ATTACHMENT C – AMENDED CONCEPTUAL STORMWATER MANAGEMENT PLAN

**38 Timor Avenue, Loganholme
Conceptual Stormwater Management Plan**

Client:	Brookmoore Group
Project Number:	BE260151
Document Number:	BE260151-RP-CSMP-02

This CSMP has been updated in response to Council's Information Request dated 25 June 2026 (Council Ref: 19536981/MILNEC).

Figure 2.3 External Catchment

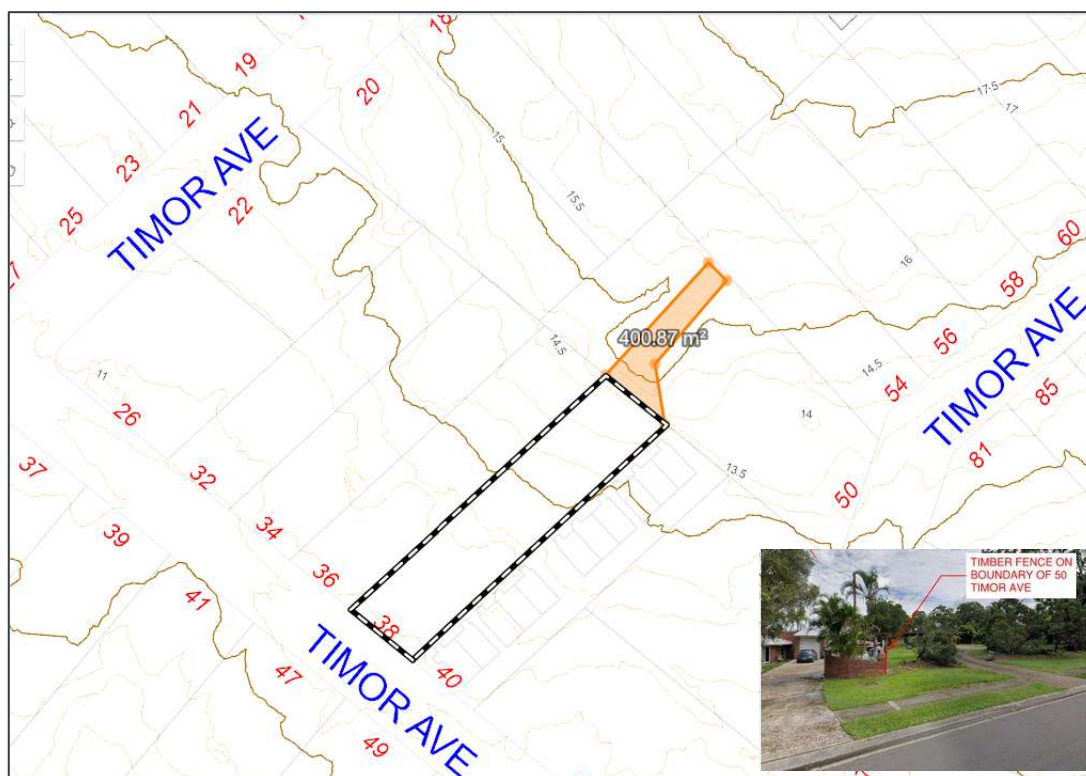
3.1.3. Amend Figure 2.3 to display the full extents of the external catchment.	The external catchment delineation has been updated. Refer to Section 2.6.

3.1.4. With reference to the item above, estimate the peak flow rates up to and including the 1% AEP event for the external catchment and demonstrate how the external catchment runoff will be collected, conveyed and discharged from the post development site.	An assessment of the peak flows of the defined external catchment and the management measures are included in Section 2.6.

There is a very minor external catchment to the north of the site as shown in Figure 2.3 below of approximately 400m². The catchment area is 100% pervious and already has a solid timber paling fence along the boundary which will contribute in retaining any flows from this catchment to the neighbouring site side as per the existing conditions.

Runoff from the external catchment is considered relatively minor and will be captured and conveyed by the pits and pipe along the proposed driveway within the site, and then discharge into the drainage infrastructure along Timor Avenue.

Runoff from in events exceeding the capture capacity of the pits will be conveyed via the proposed driveway as overland flows and discharged onto Timor Avenue.

Figure 3.2 Post-Development Catchments

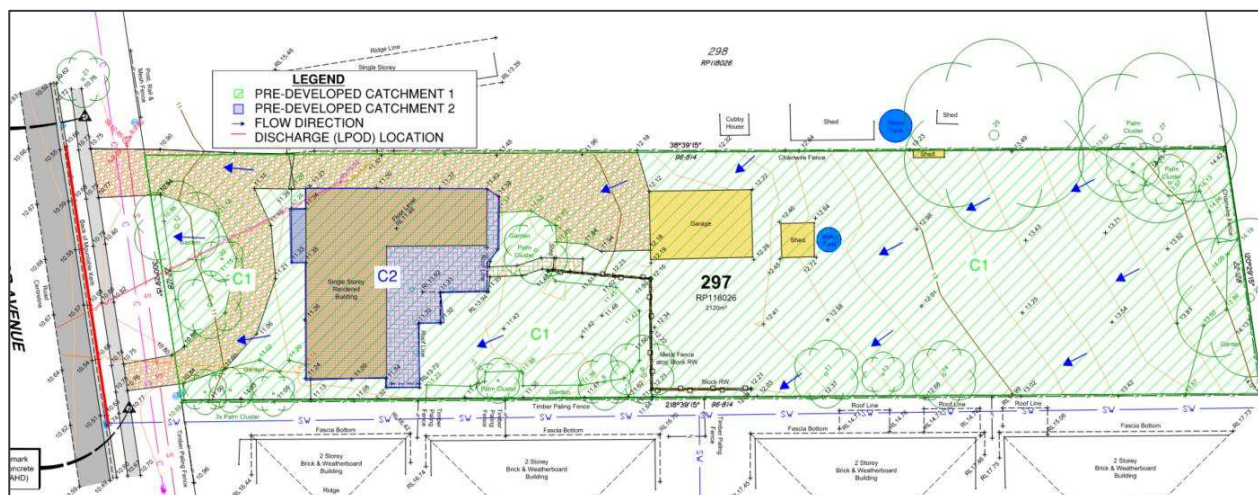
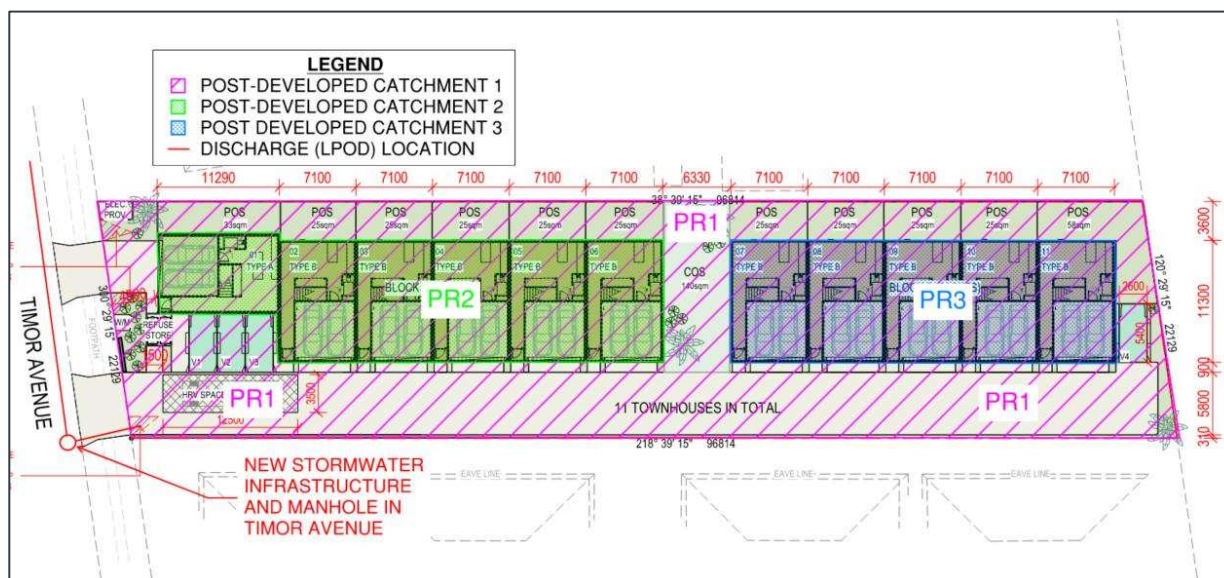
3.1.5. Clarify the operational status of the downstream stormwater pipe drainage in Timor Avenue	Operational status of the downstream stormwater pipe drainage in Timor Avenue has been included in Section 3.2.1.

3.1.6. Demonstrate there is stormwater capacity for the proposed connection of the post development subject site to the downstream stormwater pipe drainage.	A capacity assessment of the downstream stormwater pipe for site connection has been included in Section 3.2.1.

The development is proposed to connect into the new underground drainage network forming part of the approved adjacent development on Lot 298 RP118026 (Council Ref: OW/68/2026).

It is noted that the OPW Decision Notice for this adjacent development was issued on 29 May 2026, indicating that the drainage infrastructure associated with this OPW Approval (that the development is proposed to connect into) is yet to be constructed.

Based on the approved SWMP under the MCU Approval for the adjacent development on Lot 298 RP118026 (Council Ref: MCUI/37/2025), the underground drainage is designed for 10% AEP minor design storm. The mitigated 10% AEP peak flow is reported as 0.088m³/s.

The internal drainage for the site will also be designed to have a level of service of 10% AEP. Based on Section 3.4 below, the mitigated 10% AEP peak flow for the post-development site is 0.054 m³/s.

This results in a total 10% AEP peak flow of 0.142m³/s.

Based on the approved drawing (drawing number CW25130-SW03) under the OPW Approval for the adjacent development on Lot 298 RP118026, the propped underground pipe along Timor Avenue is 375mm diameter in 0.54% grade. A pipe flow capacity assessment has been undertaken with Manning's Equation to be approximately 0.14 m³/s.

Therefore, it is concluded that the proposed downstream drainage pipe is sufficient to convey the mitigated 10% AEP peak flows from both the development site (Lot 297 RP118026) and the adjacent site (Lot 298 RP118026).
